Service Bulletin

No. : MZ04-005

Model: CD5400

Subject: Jumping sound sometimes occurs during CD playback.

MAIN PCB

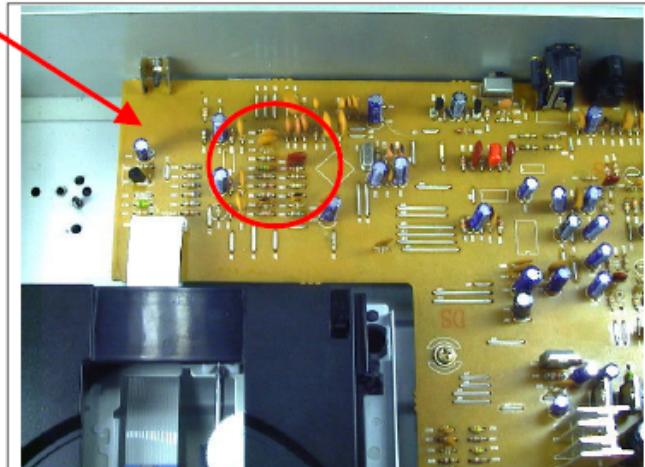
C106

C120

1. Ceramic capacitor C106 (56pF) is changed to 68pF.
2. Plastic film capacitor C120 (0.01uF) is changed to 0.1uF.
3. Carbon film fixed resistor R126 (15K ohm) is changed to 6.8K ohm.
4. Replace MICRO PROCESSOR IC71.

FRONT PCB

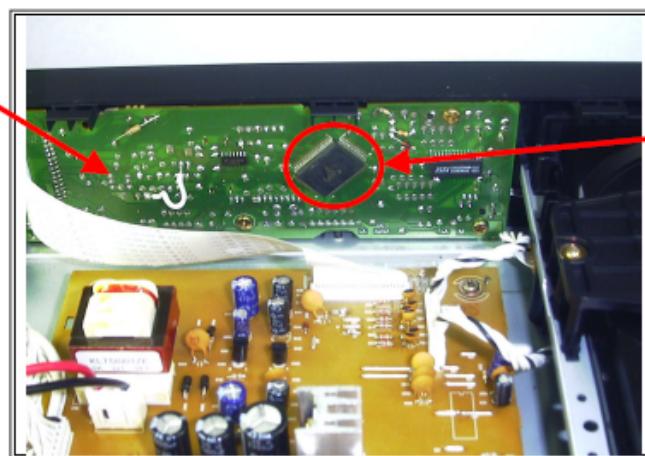
IC71
